PL202300156

BCS 5

SITE DEVELOPMENT PLANS
FOR
BCS PHASE 5

No.	Description	Date
1	Pre-Application DRC	9/6/2023

C3.0

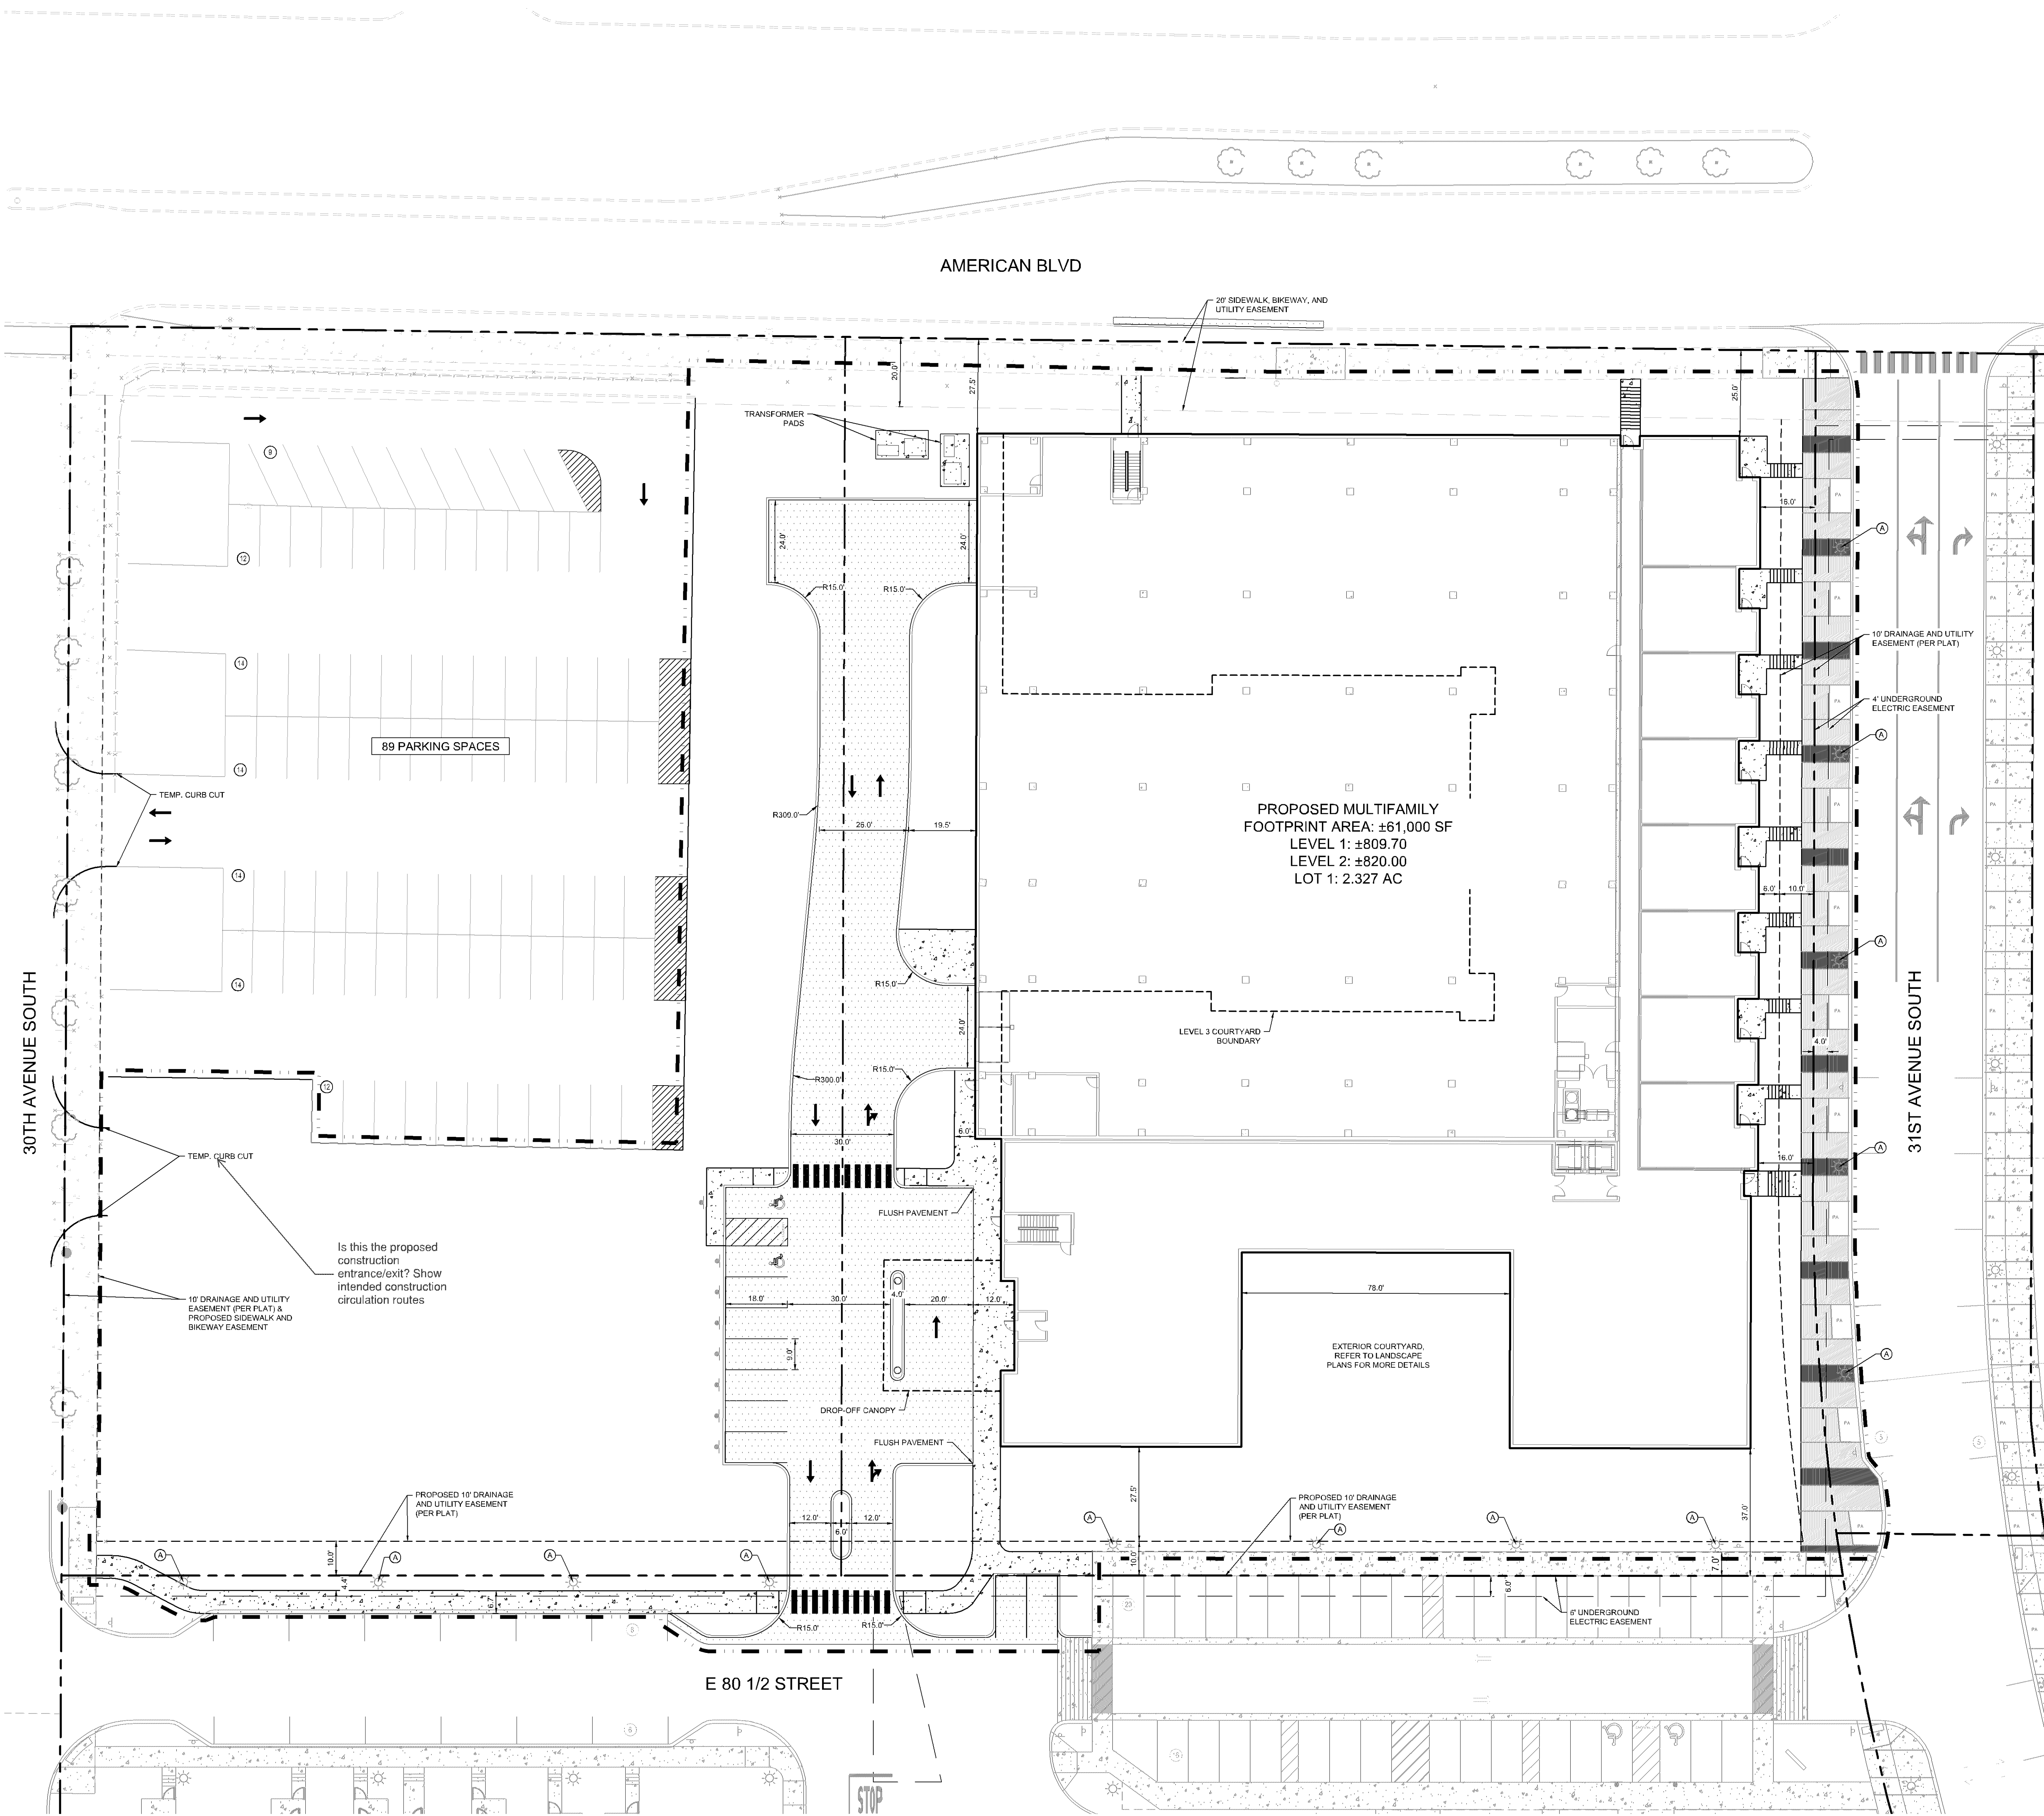
Not enough space for southbound vehicles to merge. Follow MnMUTCD guidelines

Consider removing parking space to increase visibility of pedestrian crossing

C3.1

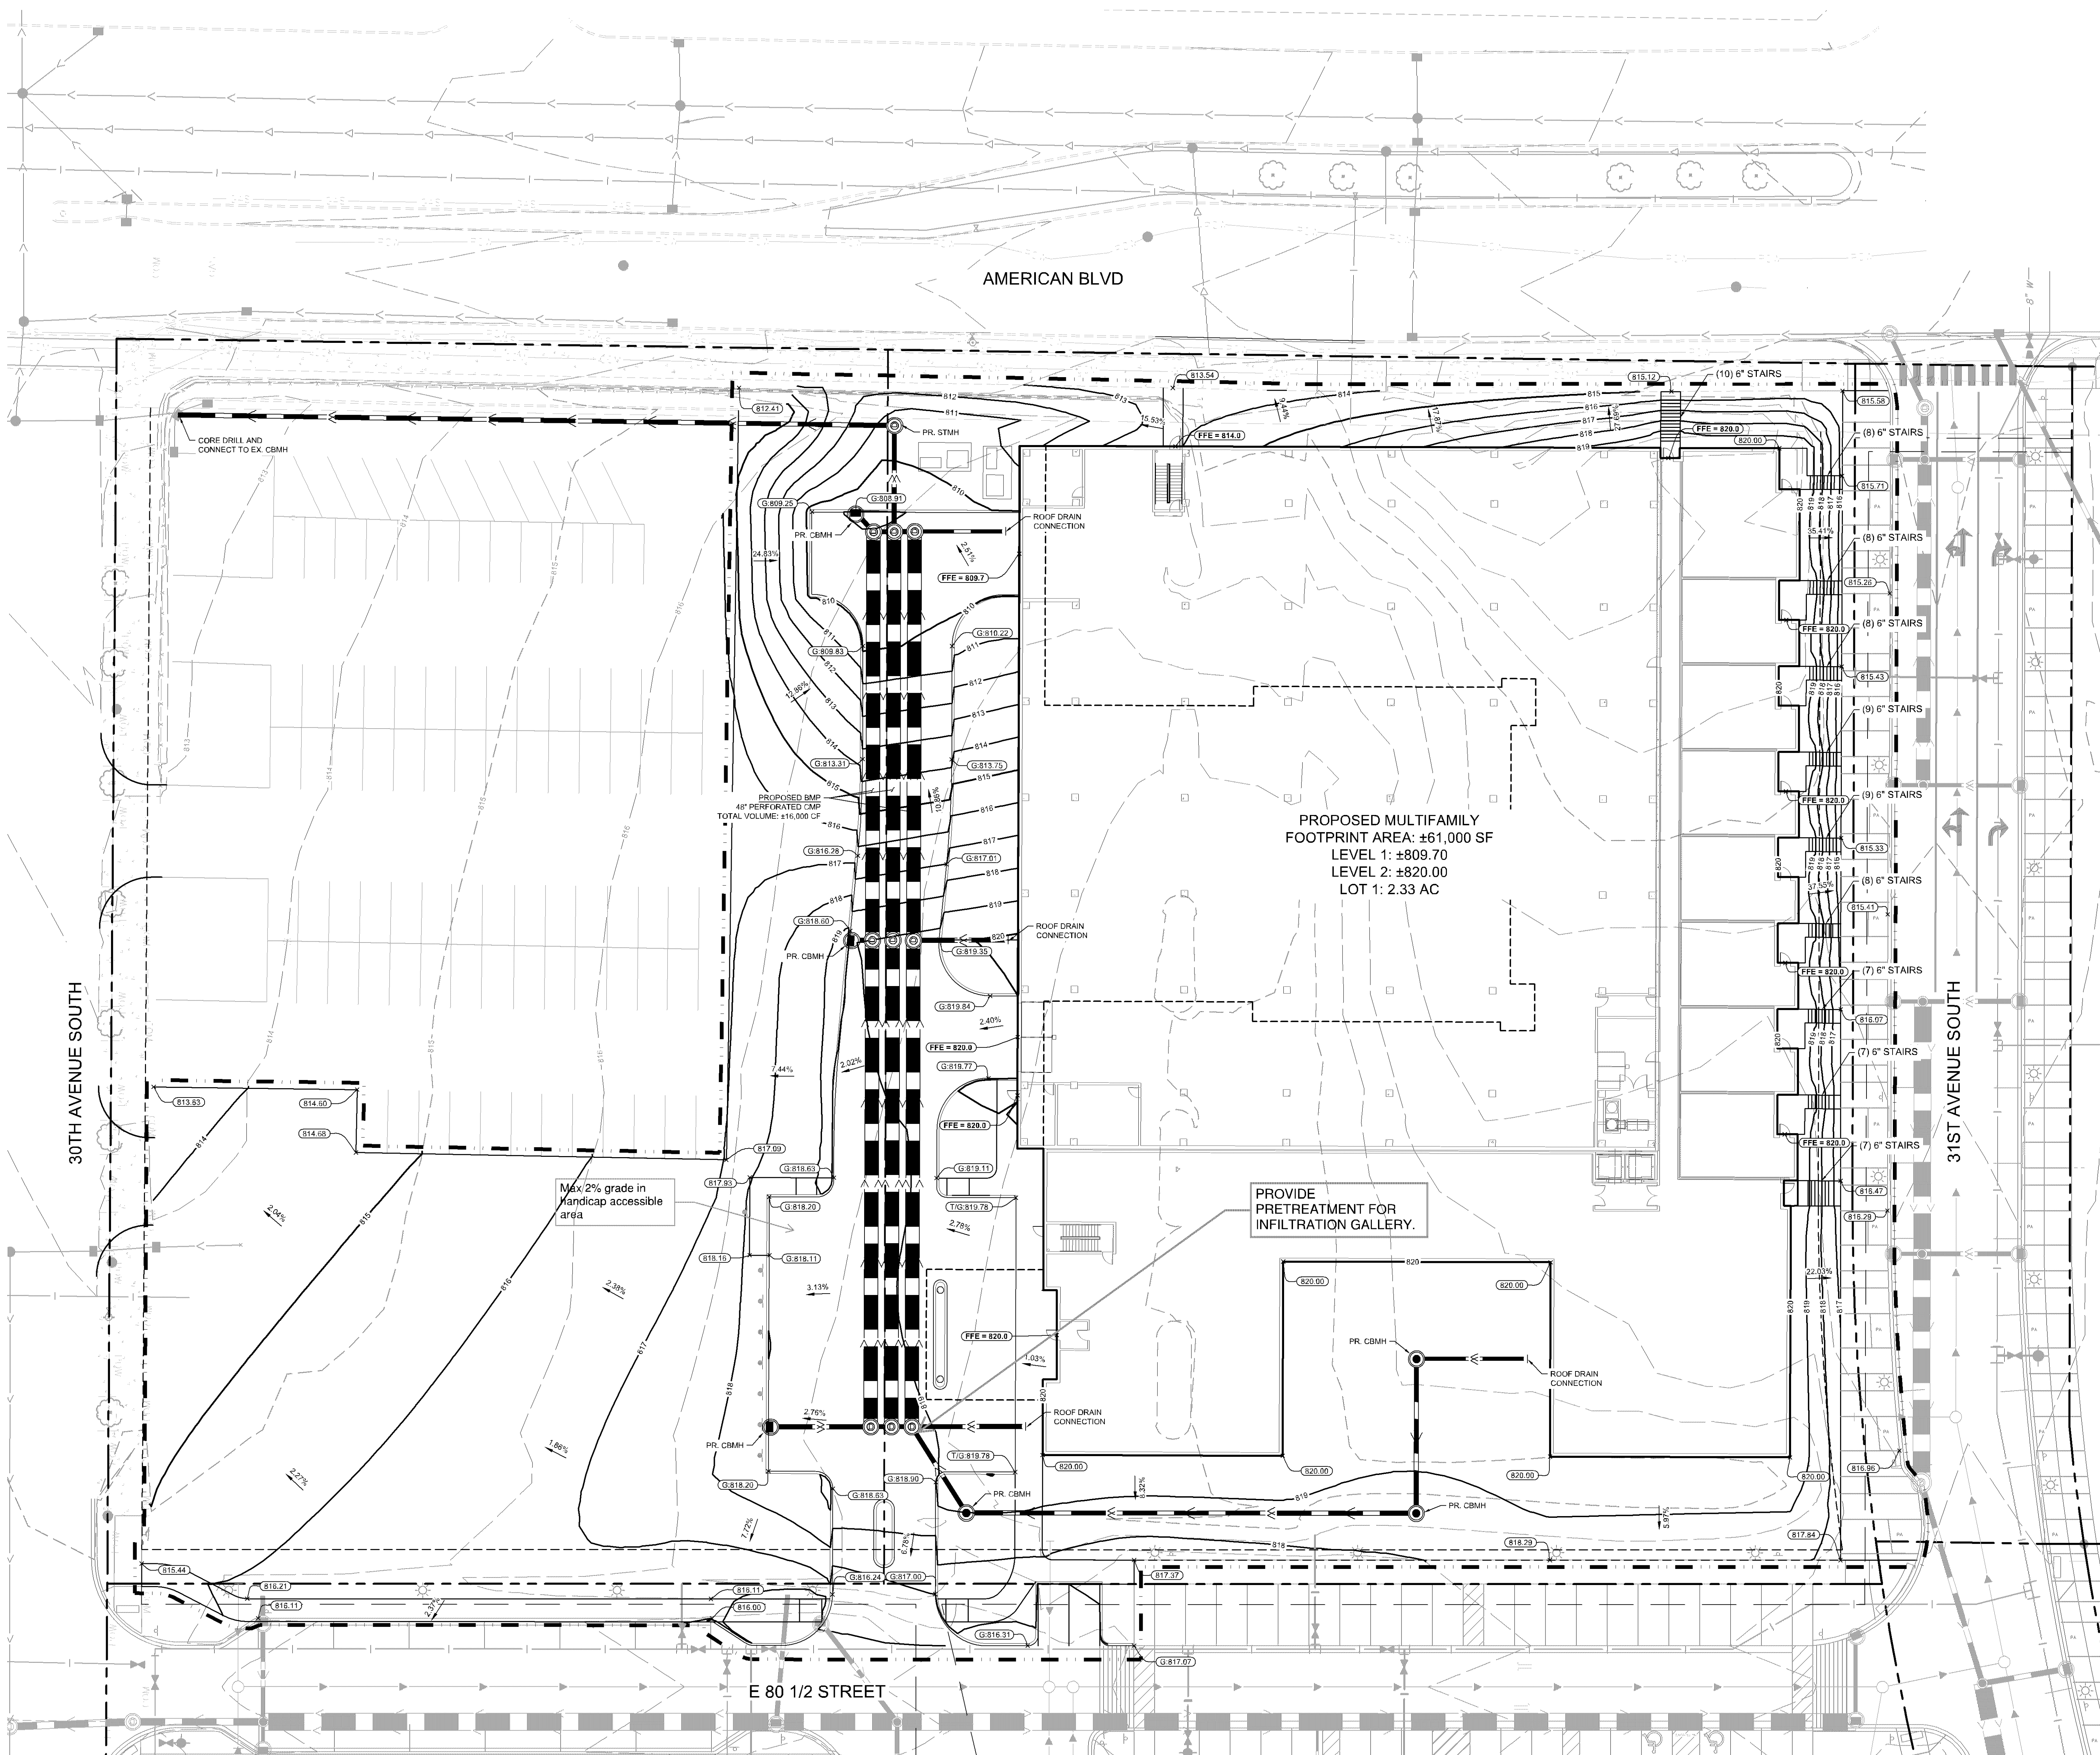
The total City Code requirement is 246 spaces. 221 spaces represents the requirement with a 10 percent reduction.

16 street stalls are proposed to be "counted" towards meeting parking supply. 28 street stalls were identified for Carbon 31. Please include a graphic depicting which street stalls are technically allotted to the various developments.
